PLANNING AND DEVELOPMENT SERVICES STAFF REPORT

For Planning Commission Meeting of December 17, 2013

**SUBJECT: Germain Motors Site Plan for City Council Approval
(2575 South State Street)
File No. SP13-048**

PLANNING AND DEVELOPMENT SERVICES STAFF REPORT

OVERALL LANDSCAPE PLAN

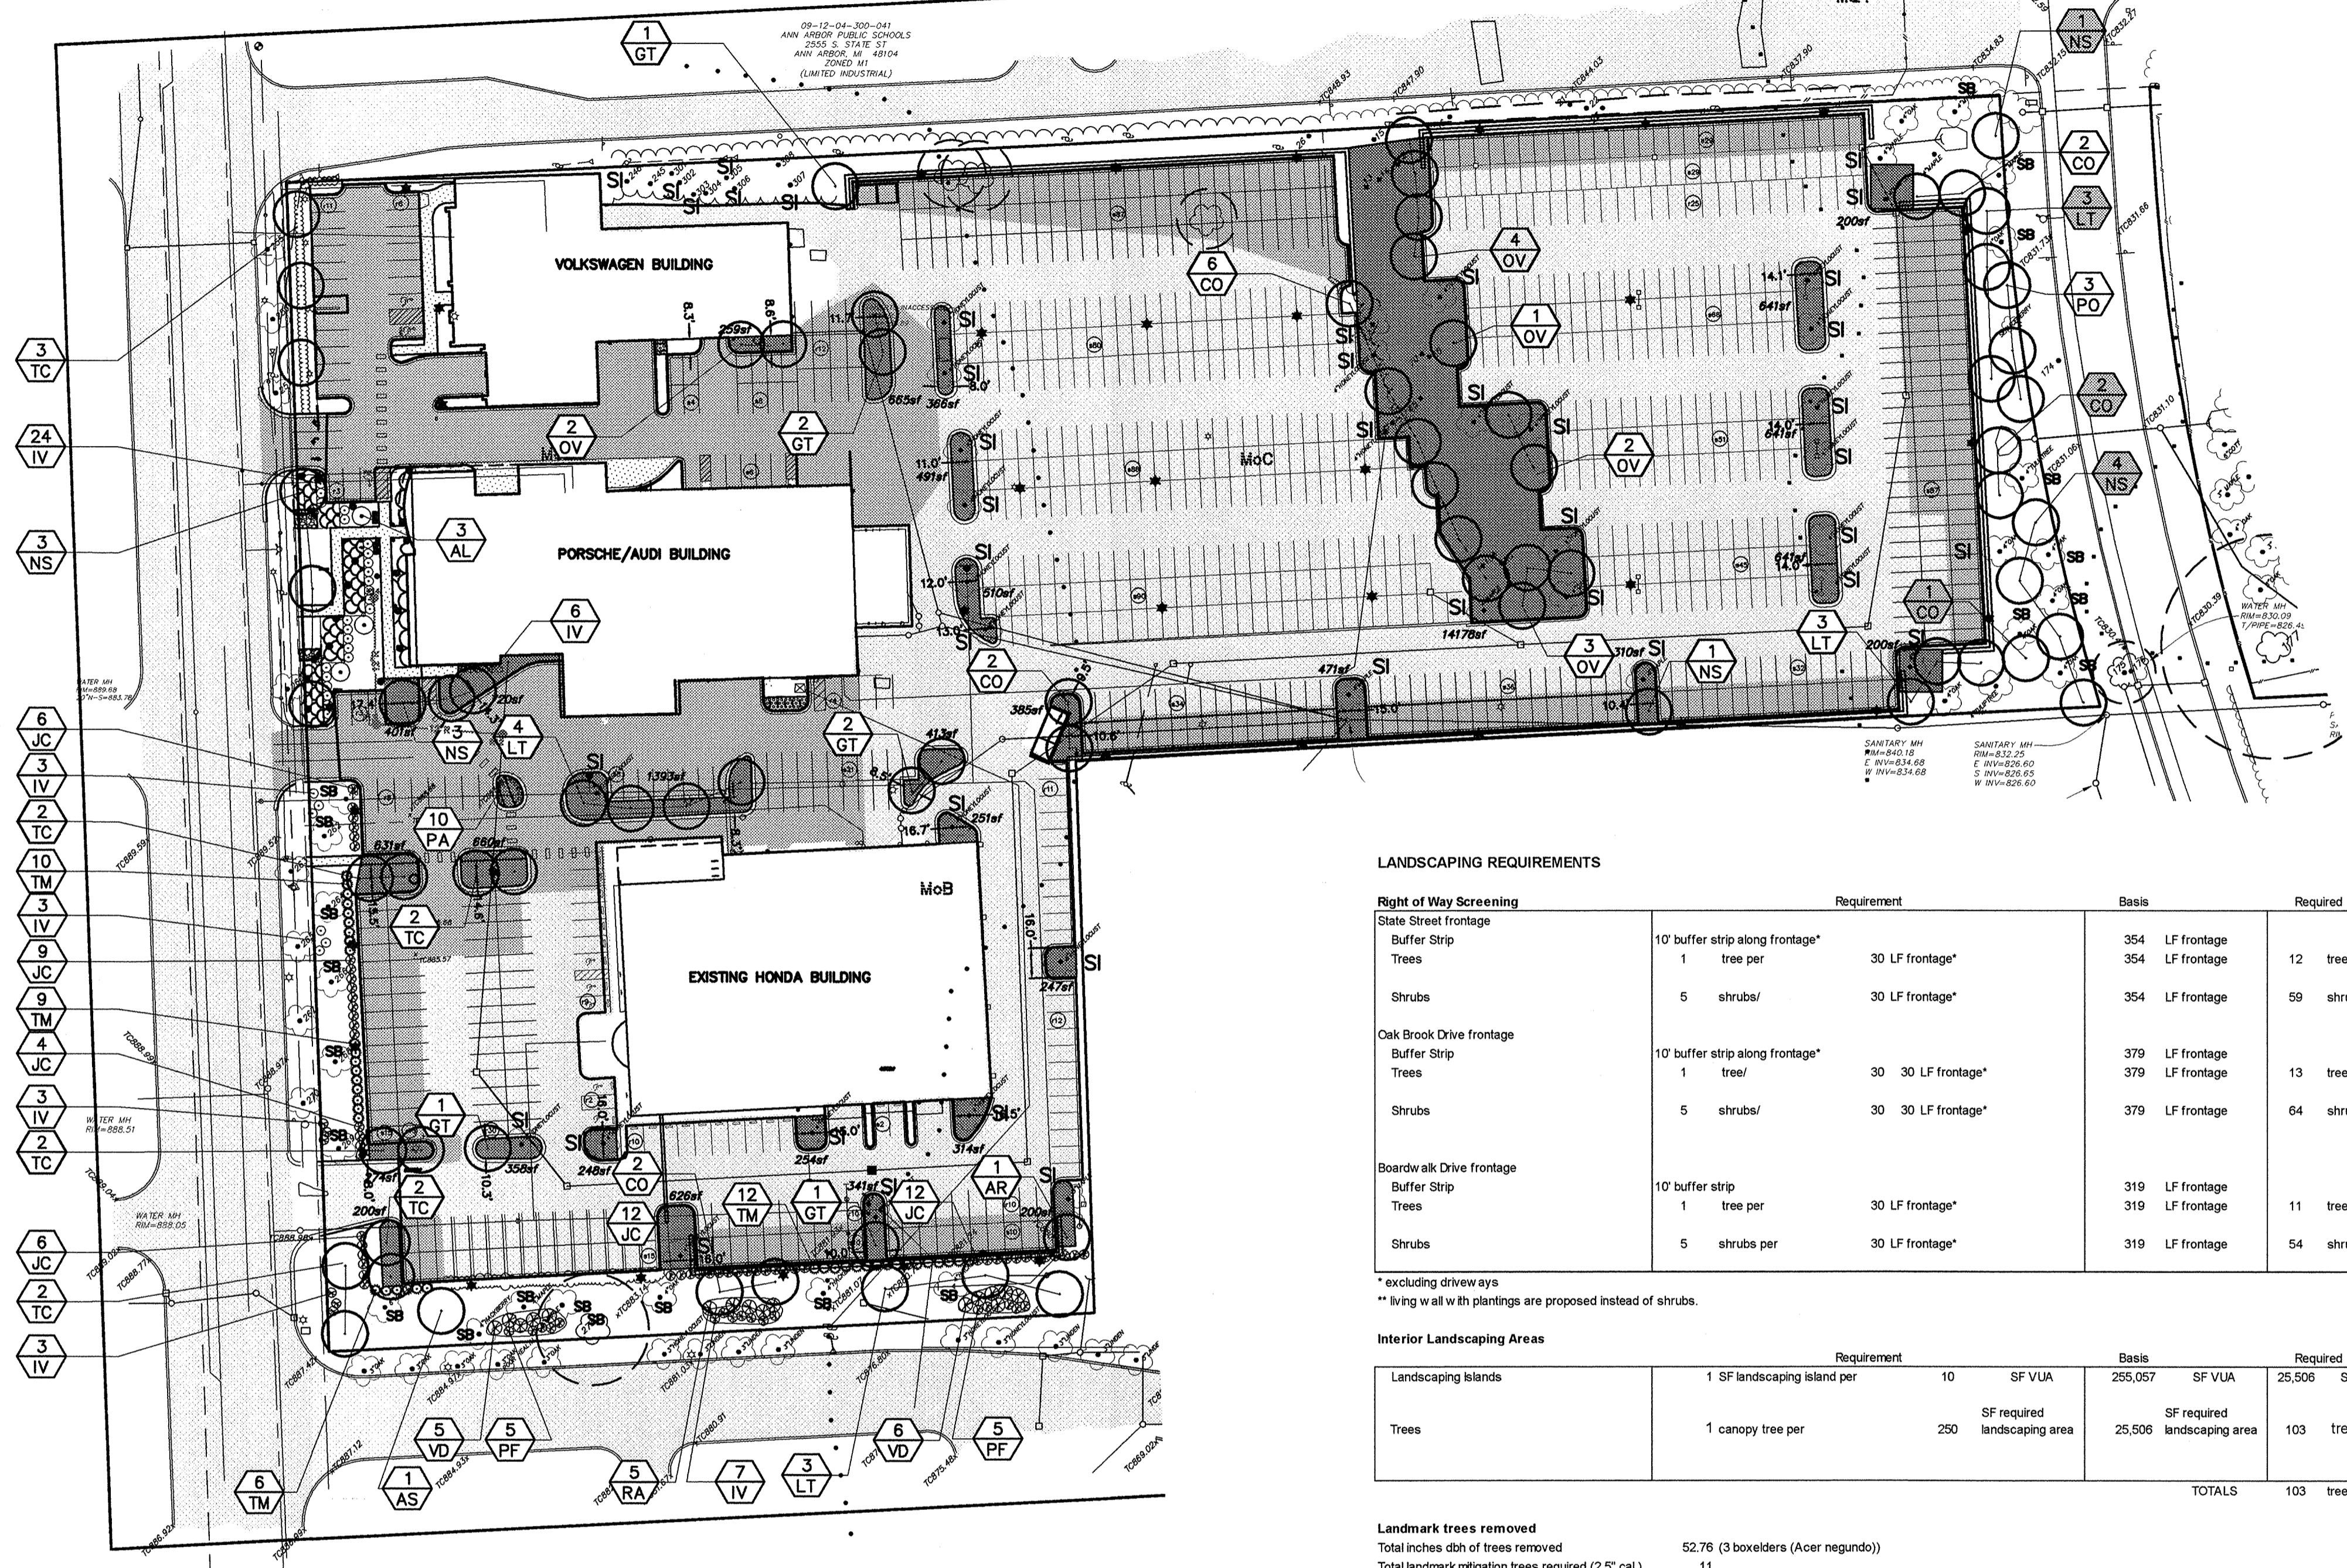
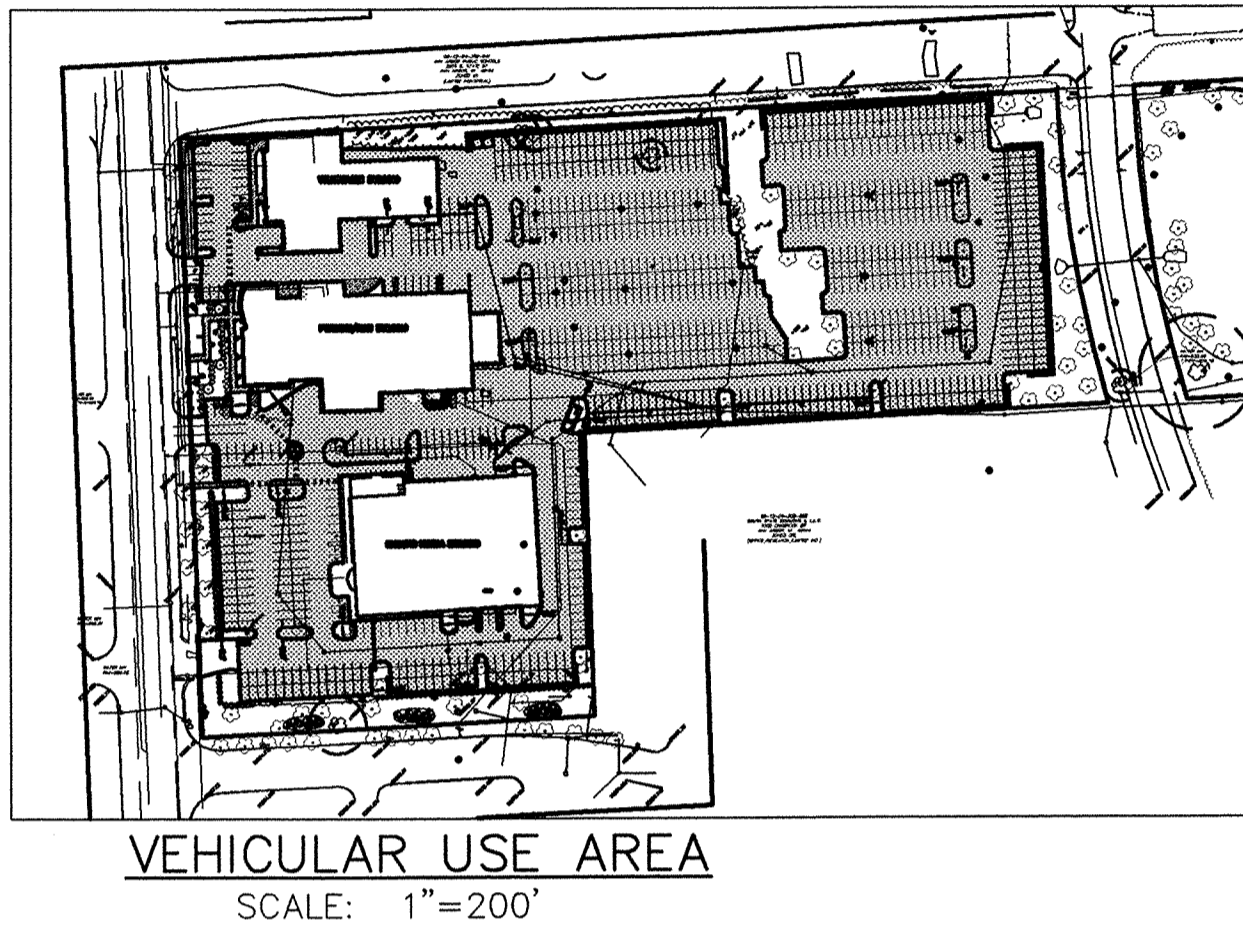
Interior Landscape Islands – The petitioner has added 8 new depressed landscape islands to the parking storage areas in the rear. Consistent with City Code, the addition of these landscape areas breaks the expanse of the parking area into no more than 15 consecutive spaces and results in the removal of 24 parking spaces. As a result, the variance request to eliminate the requirement of installing the landscape islands has been withdrawn.

The depressed landscape islands also allow for additional infiltration of storm water runoff. The landscape islands decrease the impervious surface on the site by 2,998 square feet and provide a planting area for 16 additional trees (2 trees per landscape Island).

Landscape Modification Request – The Landscape Modification has now been modified to eliminate the request for the reduction of 8 trees to be planted on site. With the additional landscape islands now proposed, all required trees will be planted on the site.

The Landscape Modification request remains in order to permit the existing landscape islands to remain without alterations (depression) that allow infiltration. Due to the location of these landscape islands and existing trees, Natural Resources staff is supportive of the revised modification request.

Natural Resources (Landscaping) – Staff does not support the requested landscape modification or variances as proposed. The petitioner has not provided significant justification to satisfy the standards for impact to the landmark trees. Staff acknowledges that the car storage area in the rear of the site functions differently than a typical parking lot, however the intent of landscape islands is more than just aesthetic or pedestrian value. Landscape islands are intended to reduce the impervious surface, assist in storm water function and help reduce the heat island effect of large paved surfaces.
